1200801 EXCAVATION AND EMBANKMENT
COMMENTS FROM INTERNAL/INDUSTRY REVIEW

The 2014 Design Standard 500, page 1 of 2.

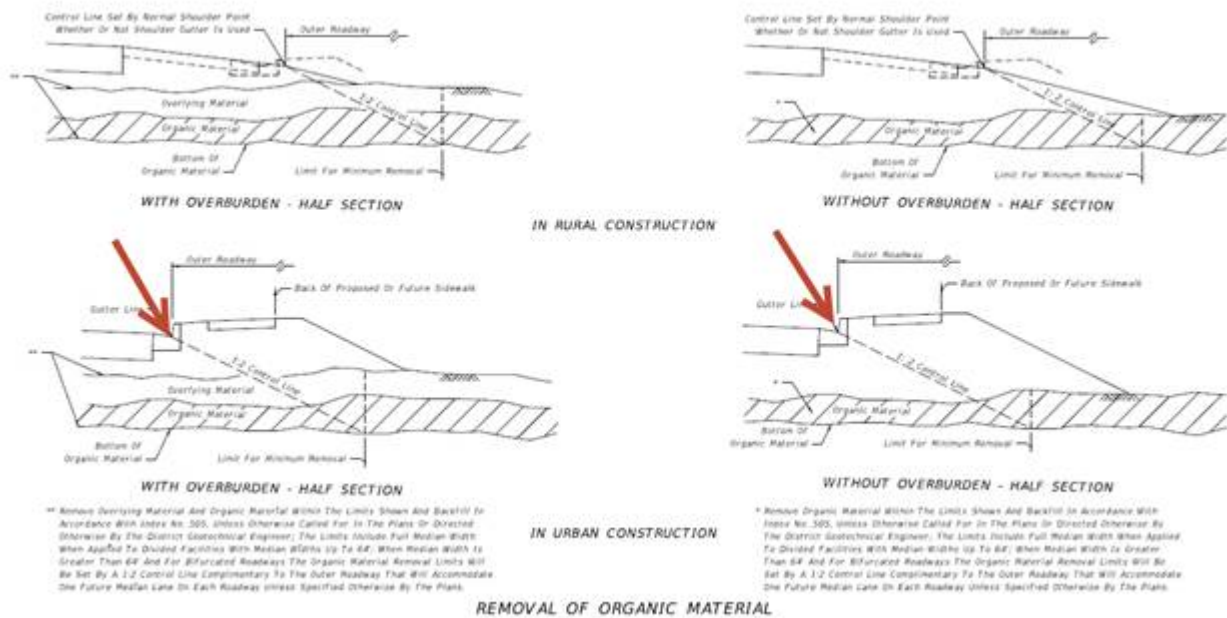
Please note the point where the control line starts, with reference to curb and the text that is used to describe the line in

Response: Our proposed definition is consistent with Index 500.
No change made.
